## Product Change Notice (PCN)

PCN Number: **PCN-0456757R**

Product(s) Affected: **SJ1-253X-SMT-TR Series (SJ1-2533-SMT-TR, SJ1-2534-SMT-TR & SJ1-2535-SMT-TR)**

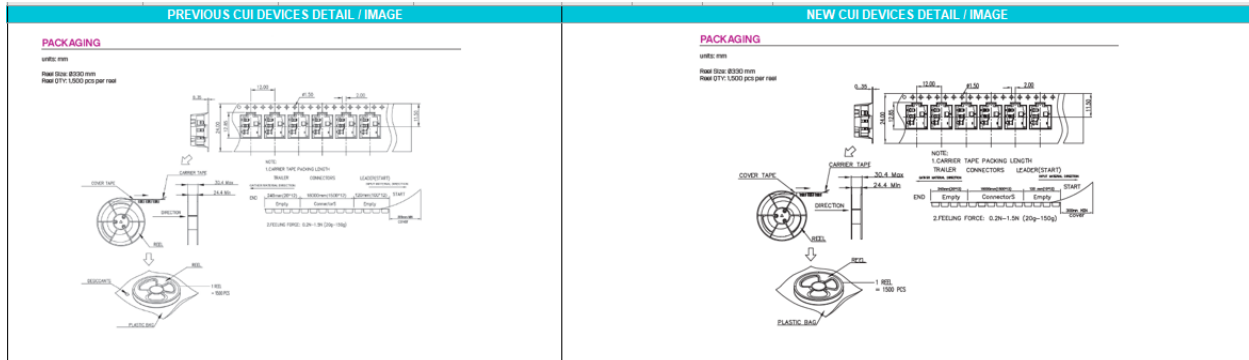
Description of Change: **New Factory Location. Product re-engineered for improved manufacturability and production yield. See image below for reference and check CUI Devices website for updated drawing. Cosmetic differences may be visible and not affect the form fit and function of the product.**

DESCRIPTION	MATERIAL	PLATING/COLOR																																																																																													
terminal 1	copper alloy	gold																																																																																													
terminal 2	copper alloy	gold																																																																																													
terminal 3	copper alloy	gold																																																																																													
terminal 4	copper alloy	gold																																																																																													
terminal 5	copper alloy	gold																																																																																													
housing	<b>PAST</b> UL94V-0	black																																																																																													
DESCRIPTION	MATERIAL	PLATING/COLOR

terminal 1	copper alloy t=0.20	gold over nickel																																																																																													
terminal 2	copper alloy t=0.20	gold over nickel																																																																																													
terminal 3	copper alloy t=0.20	gold over nickel																																																																																													
terminal 4	copper alloy t=0.20	gold over nickel																																																																																													
terminal 5	copper alloy t=0.20	gold over nickel																																																																																													
housing	<b>PA10T</b> UL94V-0	black																																																																																													
<p><b>SOLDERABILITY</b></p> <table border="1"> <thead> <tr> <th>parameter</th> <th>conditions/description</th> <th>min</th> <th>typ</th> <th>max</th> <th>units</th> </tr> </thead> <tbody> <tr> <td>lead storage</td> <td>10-30°C, &lt;75% humidity</td> <td></td> <td></td> <td></td> <td>°C</td> </tr> <tr> <td>reflow soldering<sup>1</sup></td> <td>see reflow profile</td> <td>255</td> <td>260</td> <td></td> <td>°C</td> </tr> <tr> <td>drying conditions<sup>2</sup></td> <td>parts to reflow: soak at 100°C for 4 hours parts removed from reflow: soak at 100°C for 4 hours</td> <td></td> <td></td> <td></td> <td></td> </tr> </tbody> </table> <p>Notes: 1. CUI Devices recommends to solder within 70 hours from opening vacuum packaging at a temperature 10°C &amp; relative humidity 70%. 2. When assembling, see file by click here.</p> <p>* Time 25°C to Peak Temp. --- 8 Minutes Max. * Time within 5°C of Actual Peak Temp. --- 10-40 Seconds</p>						parameter	conditions/description	min	typ	max	units	lead storage	10-30°C, <75% humidity				°C	reflow soldering <sup>1</sup>	see reflow profile	255	260		°C	drying conditions <sup>2</sup>	parts to reflow: soak at 100°C for 4 hours parts removed from reflow: soak at 100°C for 4 hours					<p><b>SOLDERABILITY</b></p> <table border="1"> <thead> <tr> <th>parameter</th> <th>conditions/description</th> <th>min</th> <th>typ</th> <th>max</th> <th>units</th> </tr> </thead> <tbody> <tr> <td>lead storage</td> <td>5-25°C, 20-75% humidity</td> <td></td> <td></td> <td></td> <td>°C</td> </tr> <tr> <td>reflow soldering</td> <td>see reflow profile</td> <td>255</td> <td>260</td> <td></td> <td>°C</td> </tr> </tbody> </table> <p>Notes: 1. CUI Devices recommends usage of the product within 24 hours after 168h to opened. After 24 hours, CUI Devices recommends drying the parts prior to use.</p>						parameter	conditions/description	min	typ	max	units	lead storage	5-25°C, 20-75% humidity				°C	reflow soldering	see reflow profile	255	260		°C

parameter	conditions/description	min	typ	max	units																																																																																										
lead storage	10-30°C, <75% humidity				°C																																																																																										
reflow soldering <sup>1</sup>	see reflow profile	255	260		°C																																																																																										
drying conditions <sup>2</sup>	parts to reflow: soak at 100°C for 4 hours parts removed from reflow: soak at 100°C for 4 hours																																																																																														
parameter	conditions/description	min	typ	max	units																																																																																										
lead storage	5-25°C, 20-75% humidity				°C

reflow soldering	see reflow profile	255	260		°C
